Product Change Notification / ALAN-24PHOE237

CCB 6274 Initial Notice: Qualification of MCSO as a new final test location for MSC030SDA330B, MSC080SMA330B4, and MSC400SMA330B4 catalog part numbers (CPN) available in 2L TO-247 and 4L TO-247 packages.

PCN# ALAN-24PHOE237

Pre and Post Change Summary

KRAFT PAPER

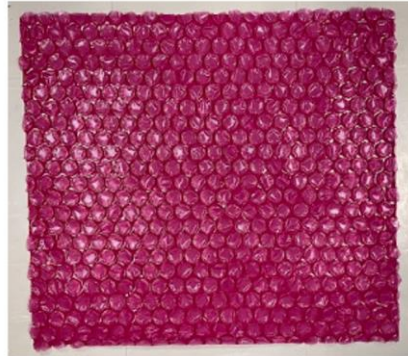
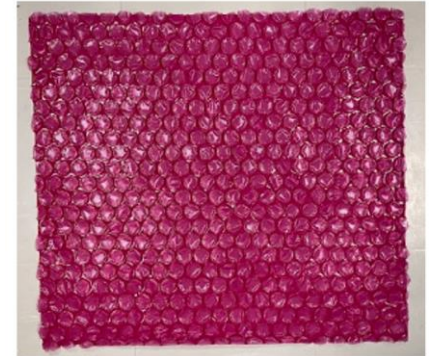
Pre Change	Post Change
Final Test Location		Microchip Technology, Inc. – Bend Office (MBND)	Microchip Technology Colorado (MCSO)
Pin 1 orientation		Left of Tube	Left of Tube
Packing Media		Tube	Tube
		No change. Please see Pre and Post change for comparison.	
Packing Media Color		Clear	Clear
Boxes		No change. Please see Pre and Post change for comparison.	
Boxes BQM	Inner Box	720 pcs/box	720 pcs/box
	Master Box	2880 pcs/box	2880 pcs/box
Fill		No change. Please see Pre and Post change for comparison.	
Packing Method		No change. Please see Pre and Post change for comparison.
